MEMORANDUM

From:	Tina Cuss Ecology Officer		
Service	WBC Ecology	App No:	252252
Address:	L'Ortolan Restaurant, Church Lane, Shinfield, Wokingham, RG2 9BY.		
Proposal:	Householder application for the proposed erection of a rooftop extension with terrace decking to the existing main building, alongside alterations to the fenestration; the erection of a rooftop infill extension to the annex building; the erection of a detached single-storey garage with dual-pitched tiled roof and facing brickwork and stone/render to match the main dwelling; landscaping and parking alterations; and the demolition of the existing single- storey rear kitchen/service extension.		
Type of Development:	Other Householder		
Site Visit Made:	No

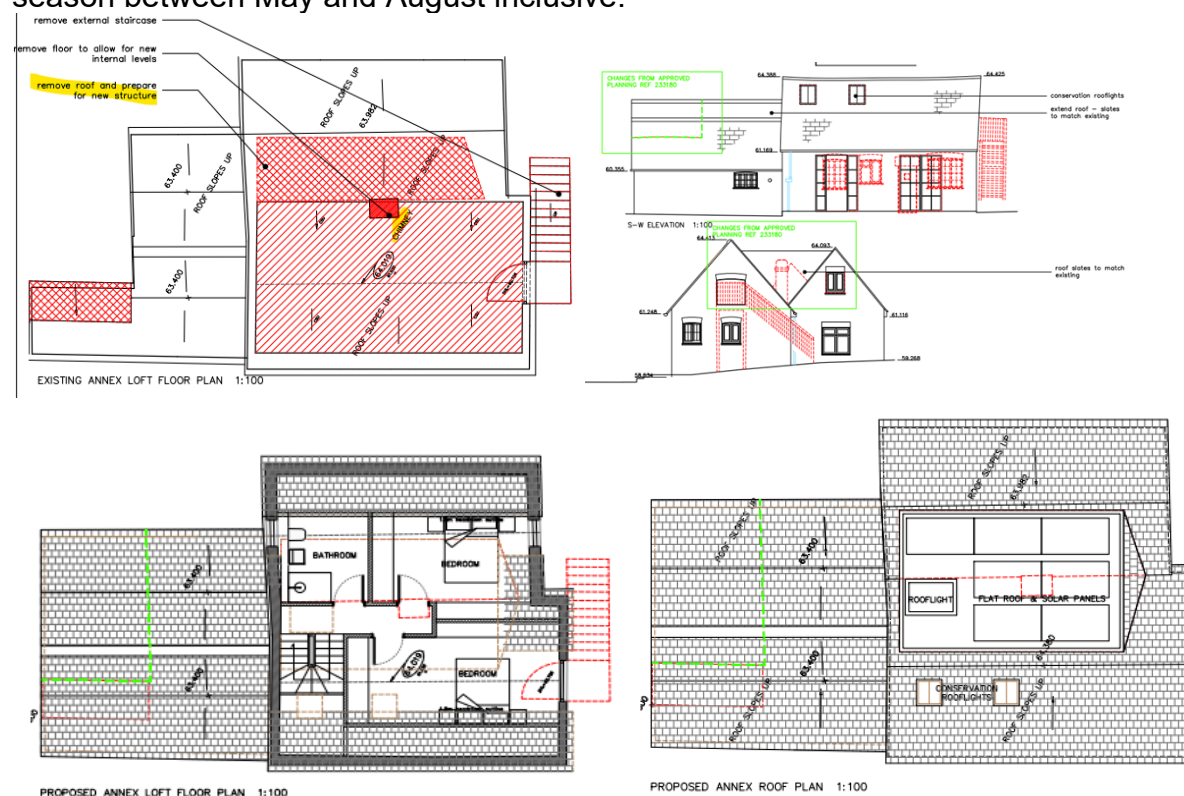
The semi-sheltered interface on the western elevation of B2, has observable gaps at junctions between buildings and under roof tiling which can act as thermal refuges and potential entry routes. The Ecologist concluded that *“given the structural links with B1, ecological risk associated with this elevation remains moderate, warranting further investigative assessment where development may directly impact roof connectivity or wall interfaces”*. However, according to the Trace Architects Existing Site Plans, the house B1 appears to be separated from the Annex B2 by a vegetable garden.

Photographic plate showing T13 (centre). (ROAVR, 2025)

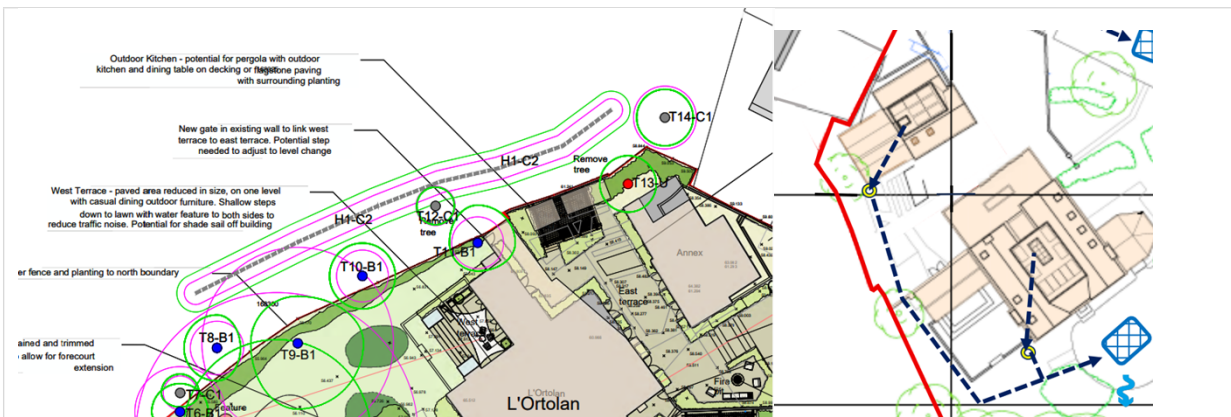
While the Ecologist assessed five trees for potential roosting features, it is not clear that the multi-stem ivy covered veteran Hawthorn T13 proposed to be felled has been assessed. While the PRA was written in August 2025, I am concerned the Ecologist has not assessed Arboricultural Impact Assessment (AIA) dated 17 July 2025. Currently the PRA report fails to take account of the loss of trees T13, T15, T17, T21, and part of G2 proposed in the Arboricultural Impact Assessment or removal of T11.

The AIA does not recommend that the removal of T11 is necessary or justify removal the tree. Annex Building Existing Plans and Elevations Drawing P07 demonstrates that the removal of T13 recommended by the Arboriculturist is not necessary. While the PRA was written in August 2025, I am concerned the Ecologist has not assessed Arboricultural Impact Assessment dated 17 July 2025.

I object to the landscape proposal to fell the Honey locust as this is not justified in the AIA. To avoid and reduce the impact of the development on bats and other wildlife I request T11 and T13 are retained. I request the amendment of the Landscape Concept Plan 15196.01 Rev D and Tree Assessment Plan 25_5837_06_70 to ensure that proposals for retention, protection, compensation and enhancement of landscape proposals are consistent with the recommendations of the Ecologist and works to trees which are adequately justified in an updated Arboricultural Impact Assessment.
